Site: Land at Eastlands Lane, Cowfold, West Sussex
Prepared by: Phil Allen MCIWEM C.WEM
Approved by: Neil Jaques
Date: 29 April 2026

1.0 Introduction

- 1.1 This technical note follows Horsham District Council's (HDC's) review of Motion's drainage strategy for the proposed development on Land at Eastlands Lane, Cowfold, West Sussex.
- 1.2 HDC have recommended a conditional consent and that more information can be provided at condition discharge. To minimise the information required to be established and produced through conditions, this technical note will provide the required information as noted in HDC's communication of 15th April 2026 (this is appended in [Appendix A](#)).

Horsham District Council Comments

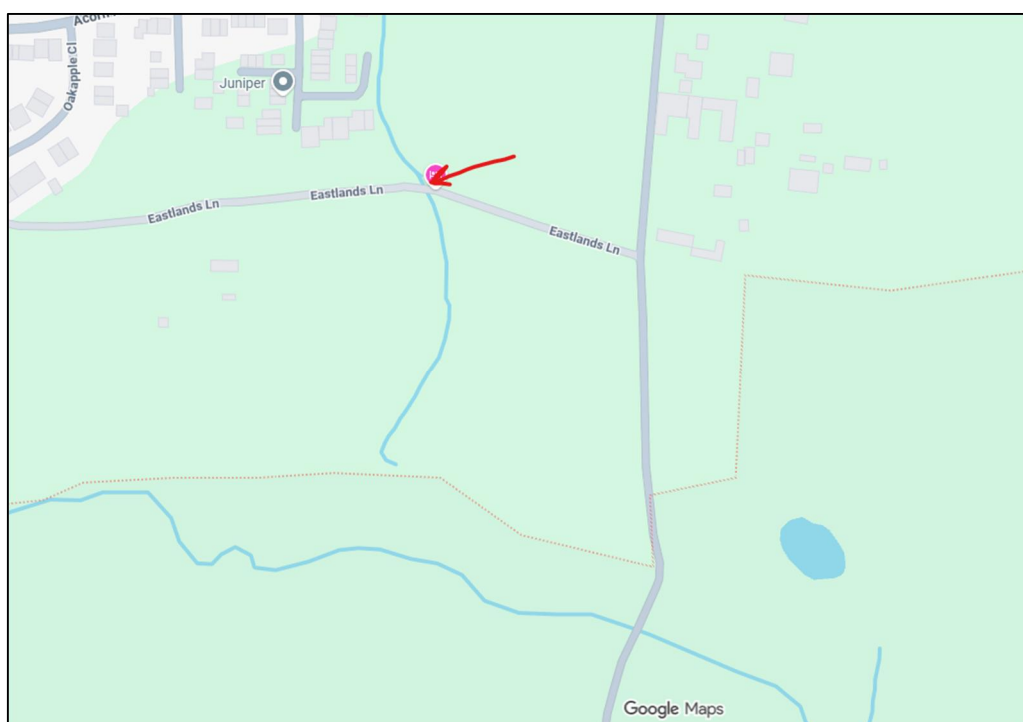
As a ditch/ watercourse is to be the intended outfall location for surface water from the proposed development, an assessment of the ditch/ watercourse must be provided, to identify whether the feature is expected...

§ *to contain flowing water throughout the year (unless there is a drought or an unusually long period of dry weather). The range of expected water levels should be provided.*

§ *to seasonally dry up or to stay dry for most of the year.*

§ *Context must be provided regarding the connectivity of the ditch and/or watercourse to waterways within in the wider landscape, as well as influences which might affect water levels in the feature, both upstream and downstream.*

- 2.23 The drainage ditch is an established part of the local hydraulic network. The connection point on the plan below shows the line of the watercourse, which flows south, before a short, culverted section within farmland after which it joins the Cowfold Stream, which is a designated Main River. Full and ongoing connectivity is confirmed.

Impermeable Area Plan

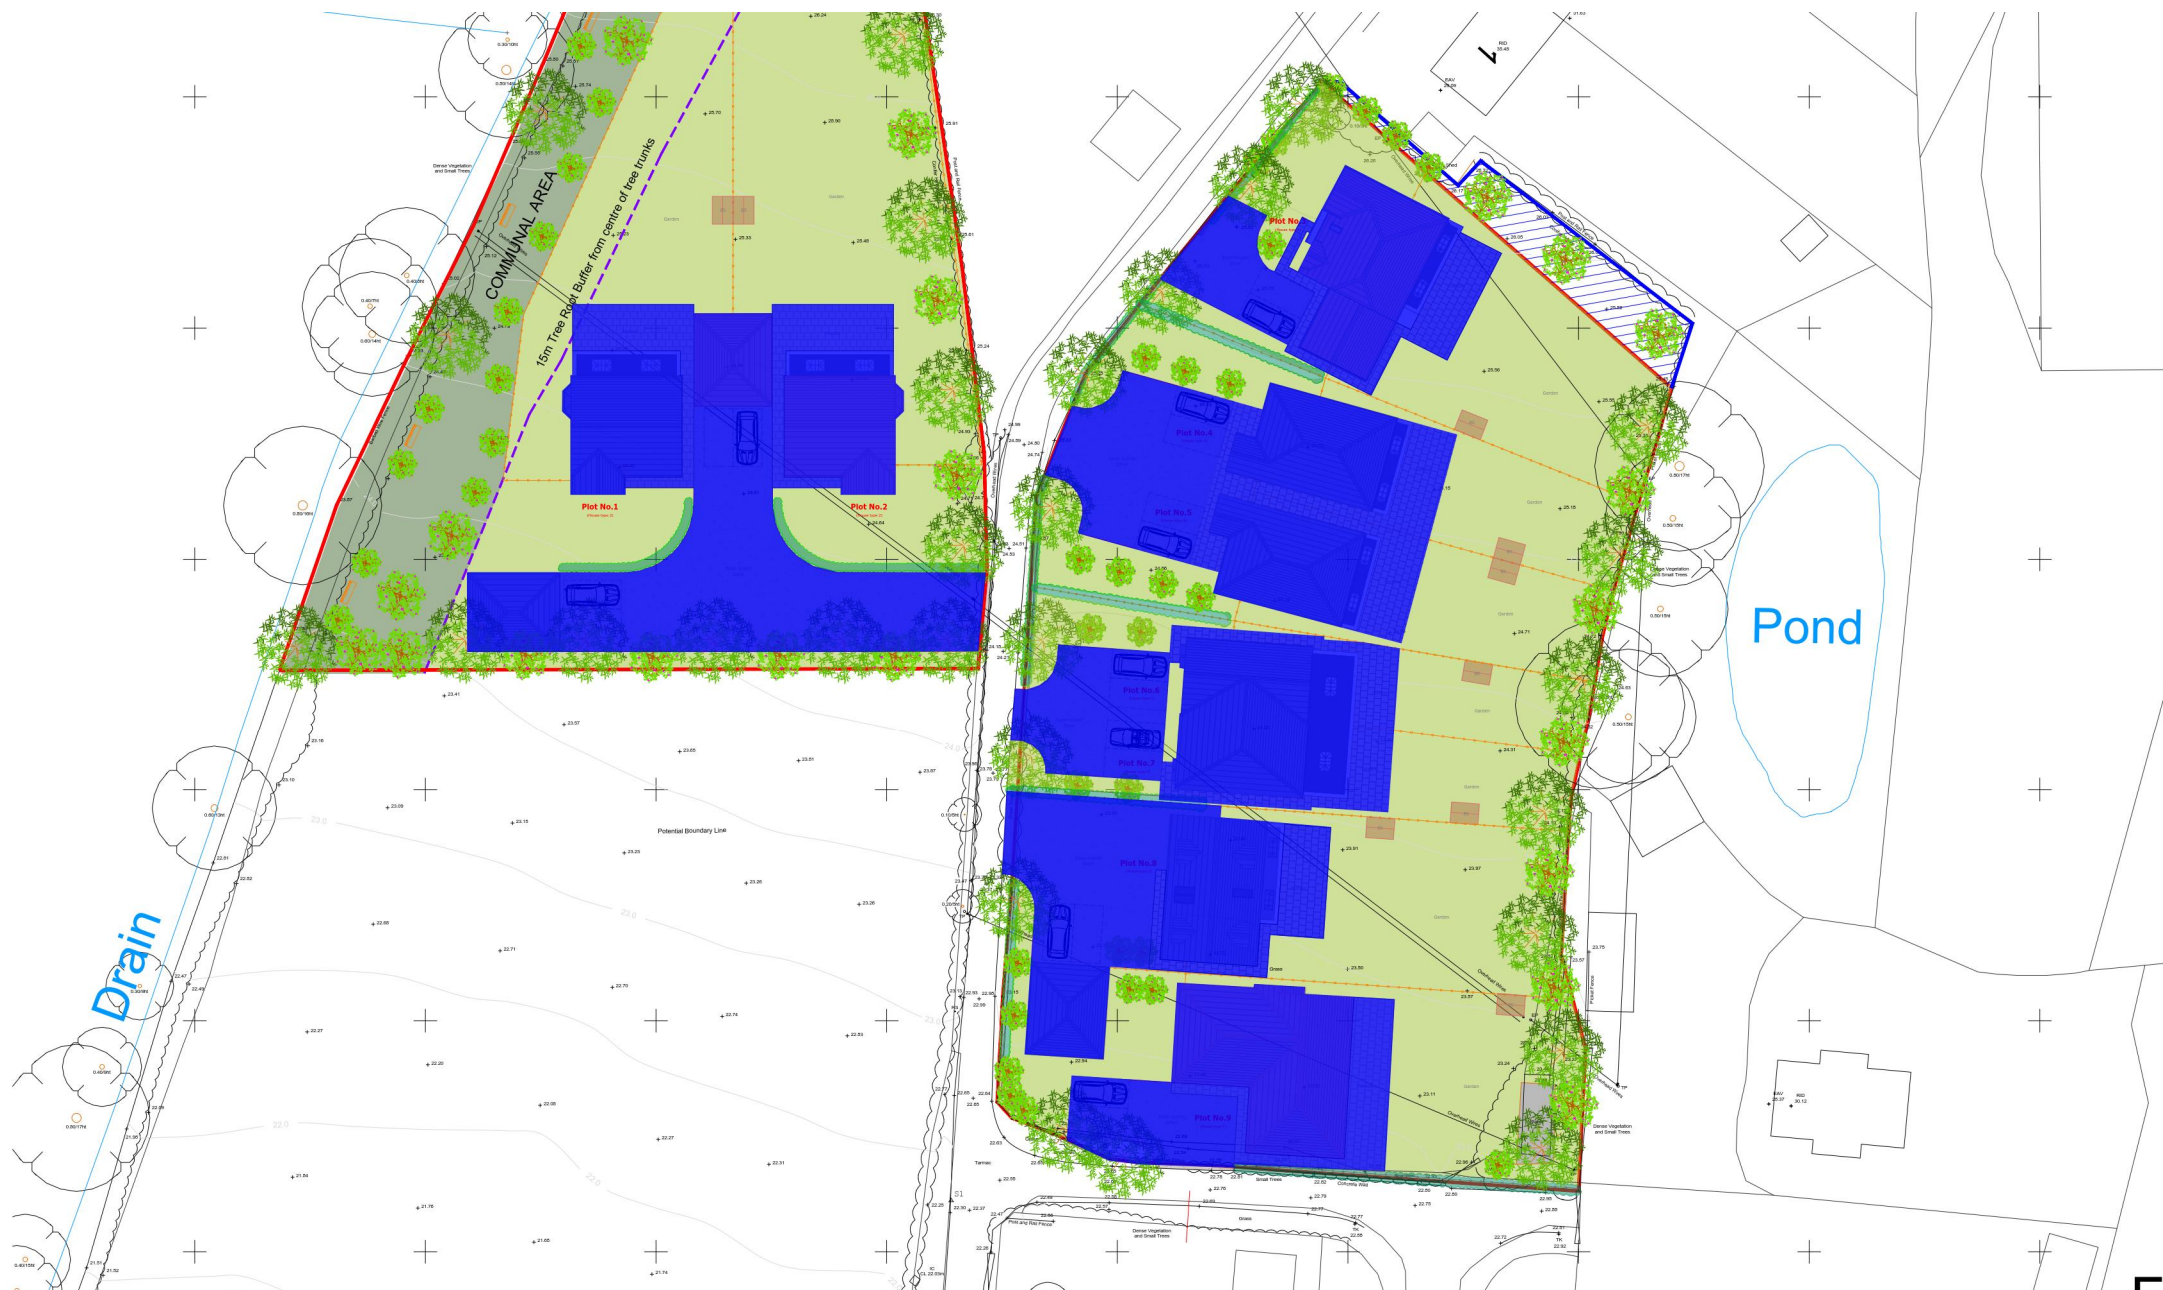
...with supporting catchment plans and calculation.

- 2.5 The impermeable areas are all the roofs, driveways, accesses and patios within the site boundary. It drains as a single catchment, so for impermeable catchment plans, please refer to the site layout and areas shaded blue in [Appendix B](#) of this report, which total 0.311ha.

Southern Water Asset Location Plan

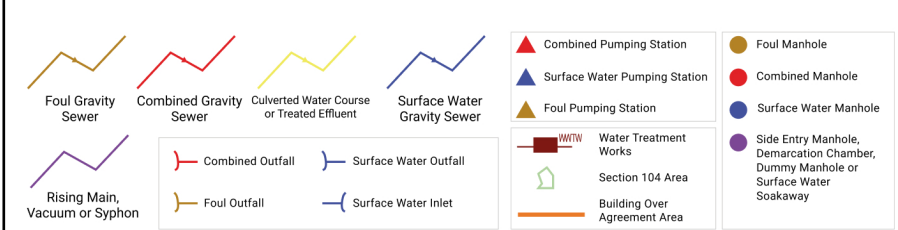
As connections to Southern Water Utilities are proposed as part of the development, supporting plans and assumed points of connection must be provided as well as expected flow rates. Connection to the public sewerage network is advised, wherever it is reasonable to do so.

- 2.6 Southern Water's Asset Location Plan was provided in Appendix F of the FRA and Drainage Strategy and is included in [Appendix C](#) of this technical note. This shows the local foul sewer network.
